**YEAR 5 of 5 Monitoring Report  
Tributaries of Wicker Branch Stream Restoration  
Union County, North Carolina  
DMS Project Number: 95022  
Contract No: 003982  
USACE Action Id No: SAW 2013-01680**

**RE: Year 5 (2019) Monitoring Report the Tributaries of Wicker Branch Project (DMS Project # 95022)**

## **APPENDIX F: 2018 IRT SITE VISIT MEMORANDUM AND RESPONSE**

Repair of log sill erosion on lower portion of  
Tributary 1B

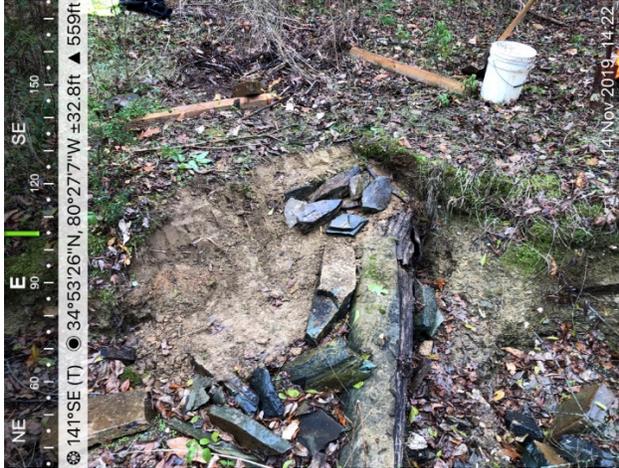
*If possible, please add a photo of the recently repaired structure on Tributary 1b.*

A photo of the repair was added to the end of Appendix B.

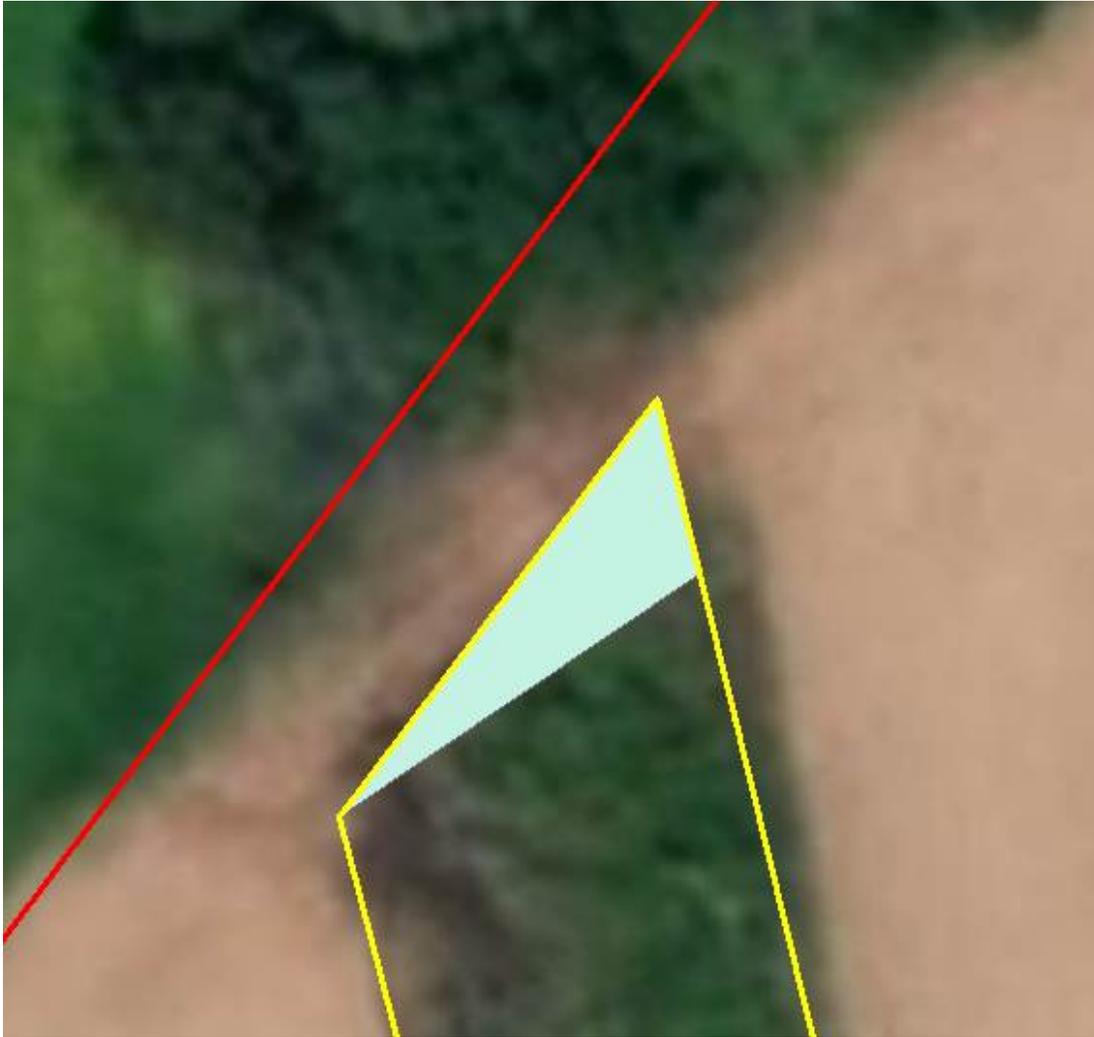
the easement with his equipment. The photo below depicts that combines that the farmer utilizes to harvest crops on the property .

The above photo depicts the location of the corner of the easement at the top of Tributary 2 in relation to the treeline. The Yellow Line is the far (northeast) corner of the easement and the wood post with the sign is the northwest corner. There is sufficient room at the northeast corner but not at the southeast corner. The photo below shows the farm equipment crossing the easement.

Expanding (or clearing) the crossing to the property line to allow for full use of the crossing would require removal of several large trees.

AECOM would like permission to modify the easement to allow adequate room for the equipment. We would work with the farmer to determine the exact distance but anticipate that it would look something like the photo above. The above photo shows reducing the length of the easement by about 35 feet on one side and maintaining it on the other. This would reduce the easement by about 1530 square feet or 0.035 acre. It should be noted that the easement in this area is not actually buffering an asset. Tributary 2 is an ephemeral feature that does not generate any stream credits.

Another option would be to not physically change the easement but just allow the area to continue to be cleared by the farmer. It would remain grassed or overgrown but no trees would end up growing on it. AECOM would like to discuss these options with DMS personnel in depth to determine a possible solution.
